#### Working Party on Lighting and Light-Signalling

## **Proposal for draft amendments to Regulation No. 104 (Retro-reflective marking for vehicles of category M, N and O)**

### **Submitted by the expert from the European Association of Automotive Suppliers\***

**Figure 3a**  
**Retro-reflective material marking of class F**

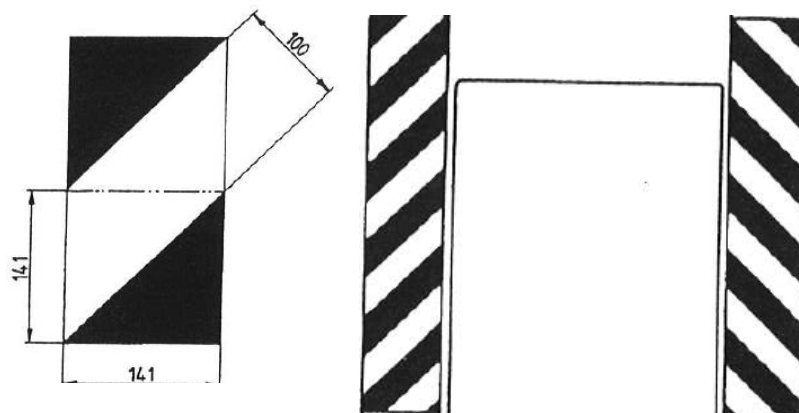
**2.2.1. Class F retro-reflective materials shall consist of red and white diagonal stripes each 100 mm wide sloping outwards and downwards at 45°. The basic standard area is a square of 141 mm in length subdivided into a white half and a red half, which represents one standard area as shown in Figure 3.**

**2.2.2. The minimum length of an element of a retro-reflective marking material shall incorporate a minimum of nine standard areas as described in paragraph 2.2.1. above on large vehicles with available mounting space, but may be reduced to a minimum of four standard areas on vehicles with limited mounting space.**
